APP/14/00993

PLAN-007683

Proposal: Change of use for nine parking spaces to hand car wash and valeting operation including installation of an office and erection of a canopy.
Site: Tesco Stores Ltd, Solent Road, Havant, PO9 1TR.
APP/14/00993

Southern Water MapGuide Browser

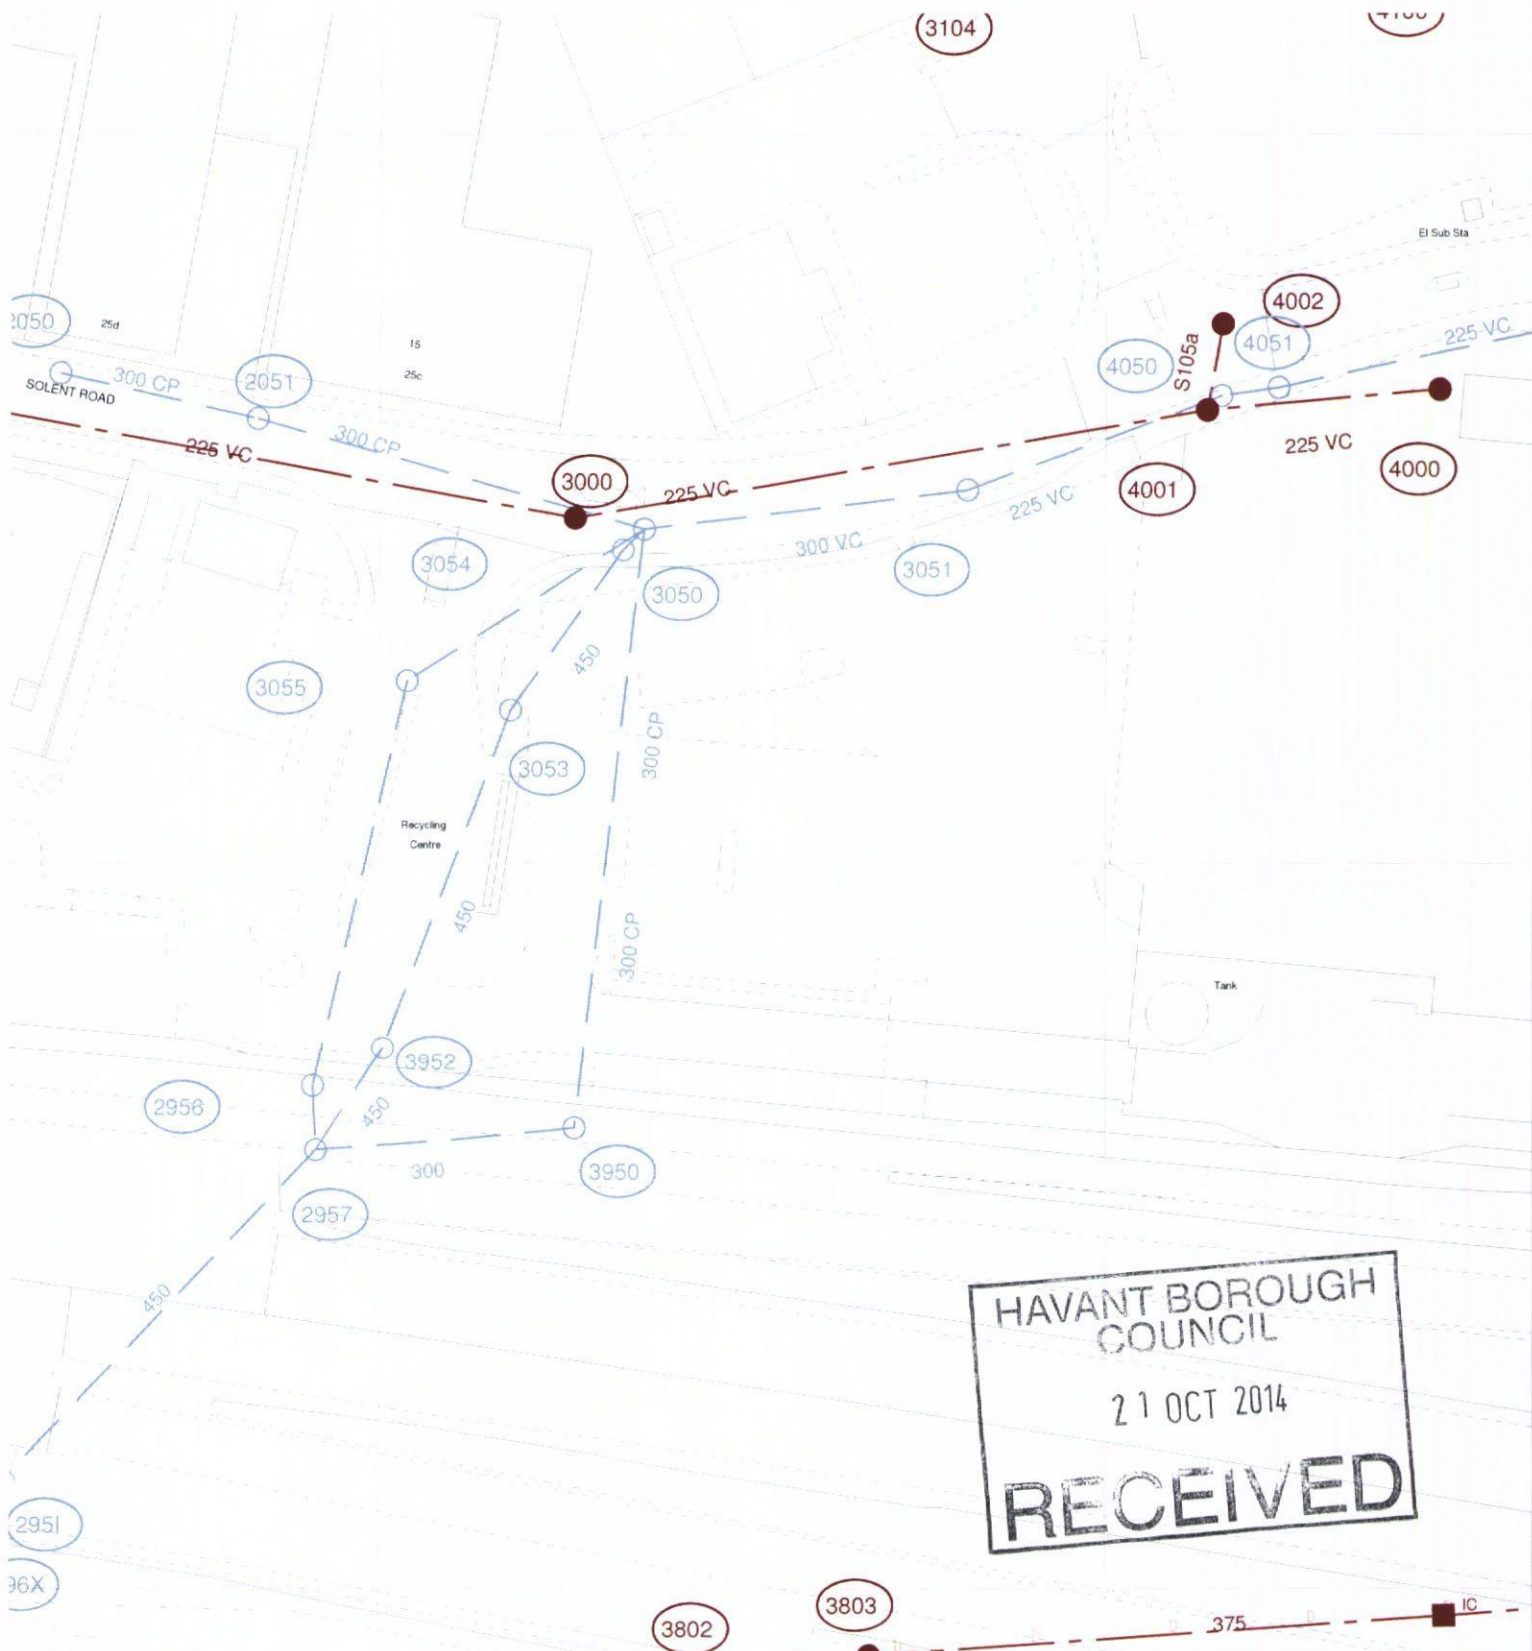
Please note: There is a decommissioned surface water sewer crossing the site.

Due to changes in legislation that came in to force on 1st October 2011 regarding the future ownership of sewers it is possible that a sewer now deemed to be public could be crossing the above property. Therefore, should any sewer be found during construction works, an investigation of the sewer will be required to ascertain its condition, the number of properties served, and potential means of access before any further works commence on site.

The applicant is advised to discuss the matter further with Southern Water, Sparrowgrove House, Sparrowgrove, Otterbourne, Hampshire SO21 2SW (Tel: 0330 303 0119) or www.southernwater.co.uk.
